AMENDMENT OF SOLICITATION/MODIFICATION OF CONTRACT		1. CONTRACT ID CODE		PAGE OF PAGES 1 2	
2. AMENDMENT/MODIFICATION NO. A001		3. EFFECTIVE DATE August 28, 2009		4. REQUISITION/PURCHASE REQ. NO.

8. NAME AND ADDRESS OF CONTRACTOR (NO., street, city, county, State, and ZIP Code)		9a. AMENDMENT OF SOLICITATION NO. X SPM070-09-Q-0041		9b. DATED (SEE ITEM 11) August 24, 2009	
		10a. MODIFICATION OF CONTRACT/ORDER NO.		10b. DATED (SEE ITEM 13)

14. DESCRIPTION OF AMENDMENT/MODIFICATION (Organized by UCF section headings, including solicitation/contract subject matter where feasible.)					
The purpose of this amendment is to make two (2) revisions in the solicitation. Reference Block 11 on receipt acknowledgement.					
SEE NEXT PAGE.					
Except as provided herein, all terms and conditions of the document referenced in Item 9A or 10A, as heretofore changed, remains unchanged and in full force and effect.					
15A. NAME AND TITLE OF SIGNER (Type or print)			16A. NAME OF CONTRACTING OFFICER Carolee Cooper, Contracting Officer		
15B. NAME OF CONTRACTOR/OFFEROR		15C. DATE SIGNED	16B. UNITED STATES OF AMERICA BY <i>Carolee C. Cooper</i> (Signature of Contracting Officer)		16C. DATE SIGNED 8-

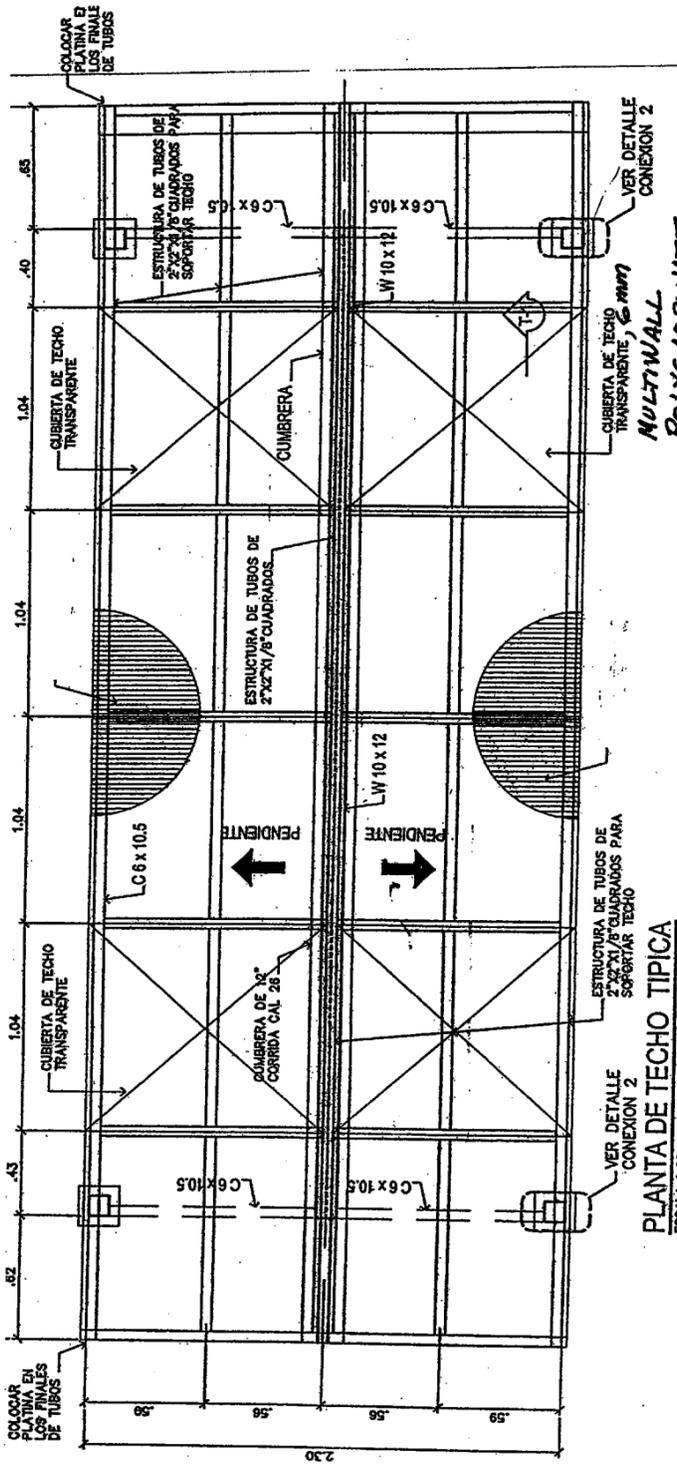
Paragraph 2.11 is added to the Attachment #1, Specifications:

2.11 Provide stairs from side by side of the fuel dispensing system. Stairs should have two treads and the landing, and three risers following the drawing added.
